Response to Submissions (RtS) – Sydney Opera House DA 43-2-2004 MOD 5

This RtS has been prepared by the Sydney Opera House (SOH) in response to comments and issues raised by Heritage NSW and the Department of Planning, Industry and Environment (DPIE) on the proposed Tours Immersive Digital Experience (TIDE) modification application.

Appendix A – response to issues

Appendix B – response to NSW Heritage

Figure 1: TWG storage will be relocated from Area 2 (proposed TIDE space) to Area 1

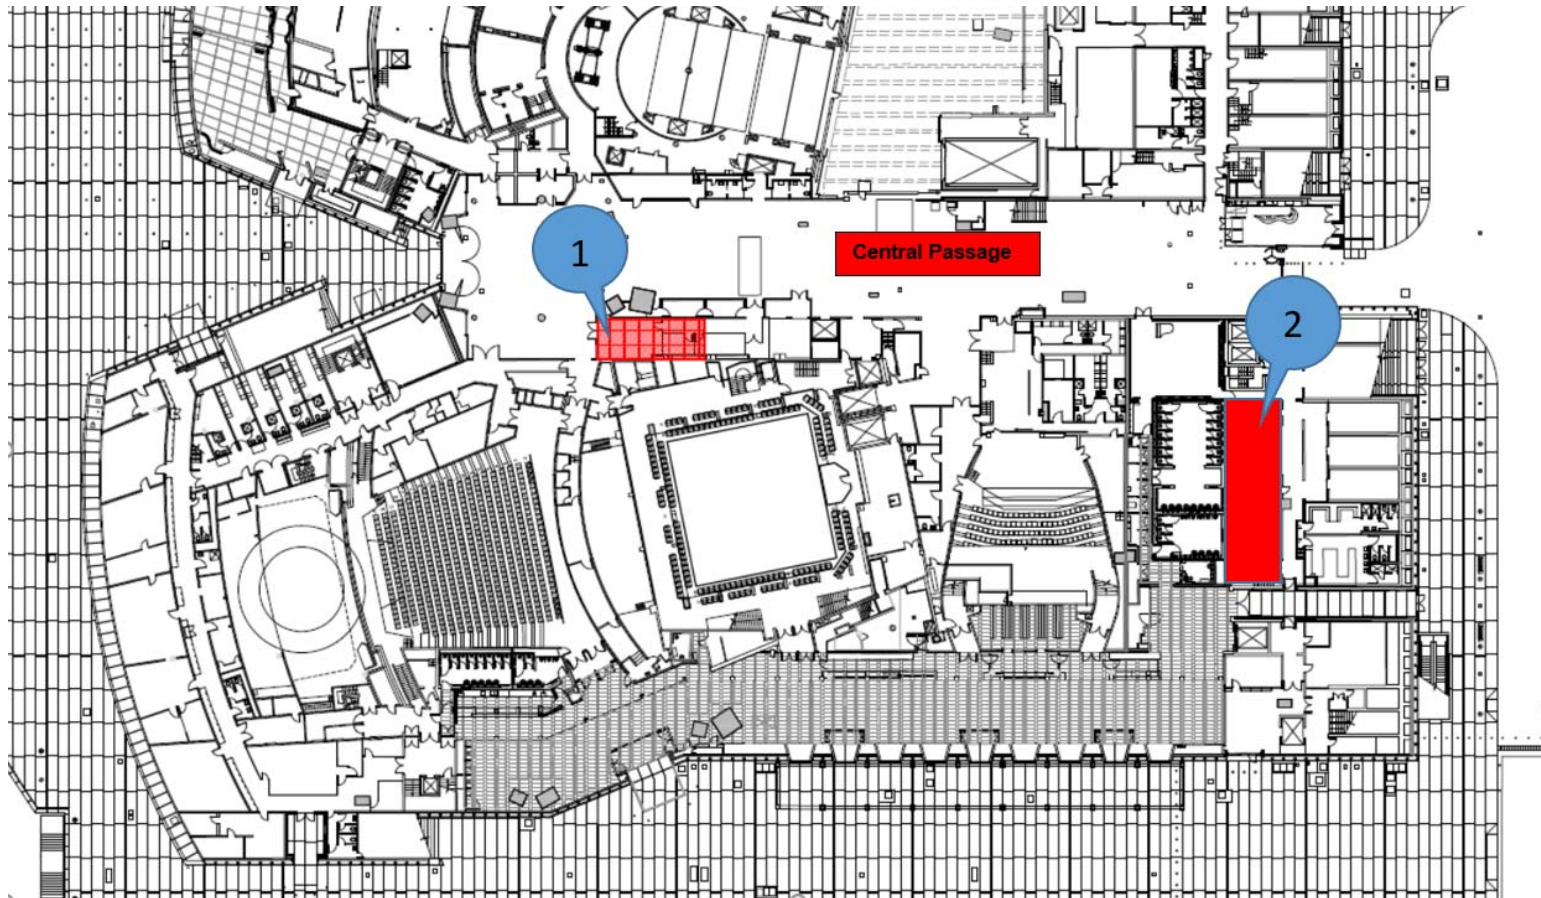
- *The Department requires that you provide further details as to where the current back-of-house facilities are proposed to be located and assess any consequential impacts that may arise.*
- *Details should be provided indicating where the current facilities are proposed to be relocated to ensure any impacts from the relocation can be appropriately assessed.*

The reuse of the current back-of-house storage space to facilitate TIDE has been enabled by moving some items offsite and rethinking existing food and beverage storage areas to ensure they are being used more efficiently.

Trippas White Group (TWG) currently uses the proposed TIDE space as a culinary store, office and cool room. SOH is proposing to relocate TWG from Area 2 to an existing storage space at Area 1 (see **Figure 1**), off Central Passage.

TWG has been consulted on the relocation and is supportive. Area 1 will allow for more efficient operations, being centrally located and closer in proximity to the Yallamundi Rooms and kitchen, and the theatre bars, which are a core part of their operation.

Minor fit out works such as installing shelving within Area 1 will ensure there is adequate storage for TWG. The Heritage Impact Statement (HIS) prepared for the TIDE proposal notes that the fit out of Area 1 will not compromise any significant fabric and will be closer to TWG's kitchens. TWG will also continue to have access to existing, underutilised office and cool room space on level B1 of the SOH.

Figure 2: Elevation E4/s200 within sheet S250

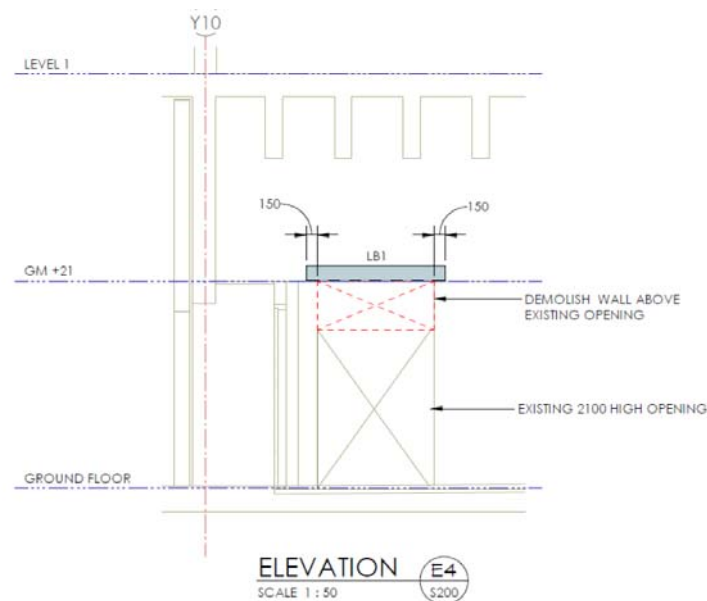
- *It is unclear how the new opening within the 1968 podium structure will be detailed including to the cut edge.*

Elevation E4/s200 within sheet S250 (**Figure 2**) demonstrates the minimal demolition of the 1968 concrete podium wall above the existing opening. This elevation shows the lintel support detail required to form the new door opening. The new lintel will extend 150mm over the opening for structural stability.
